SERVICE LETTER: JSL 004-1
Issue: 1
Date: 29th January 2008
Subject: J230 Family Engine Cooling

The changes detailed herein are primarily designed for production J230 aircraft. However, they may be applied to any Jabiru Aircraft with a 3-door fuselage and cowlings as shown below.

Serial Number Range: J292 to J578

Figure 1 – Gull Wing Baffle Installation

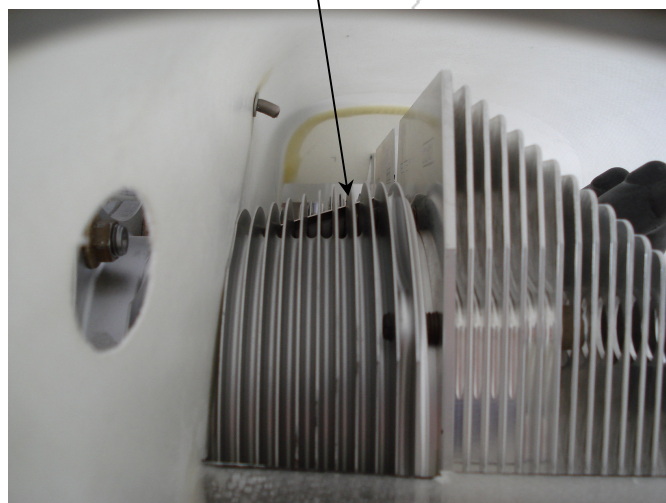
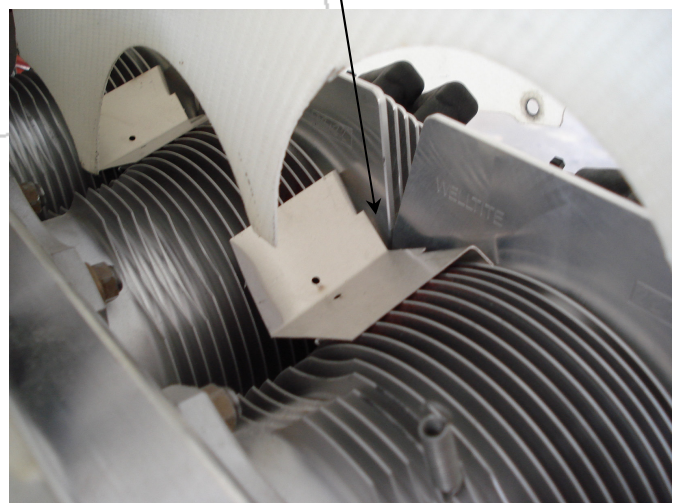
Figure 1 below shows the gull-wing baffles which have been fitted to factory-built J230 aircraft as standard.

These baffles are to be removed as a part of this modification.

Removing the baffles has the effect of blowing cool air over the sides of the crankcase and sump – while moving hot air produced by the exhaust out of the cowls more quickly.

Figure 5 – Dipstick Assembly

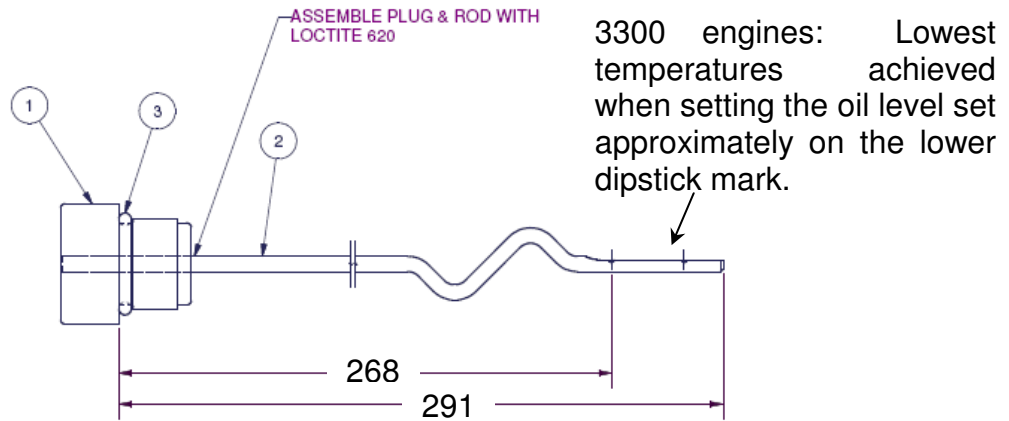
- Engine oil level has a strong effect on oil temperatures. For all 3300 engines, the lowest oil temperatures are achieved when the oil level is set on the lower dipstick mark. Generally, this oil level is suitable for circuits or flights up to 3 hours duration. Note that testing has shown that setting the oil level slightly above the upper dipstick mark (i.e. slightly “over-full”) can result in oil temperatures 15°C higher than when set at the lower mark. Figure 5 shows the length of the Jabiru 3300 dipstick.

This applies to all Jabiru 3300 engines and to Jabiru 2200 engines prior to S/No. 22A-2440. HOWEVER, more recent Jabiru 2200 engines (S/No. 2440 onwards) have a different sump (easily identified by it’s lack of fins). Setting the oil level on the lower mark in these engines will give oil levels lower than is optimal.
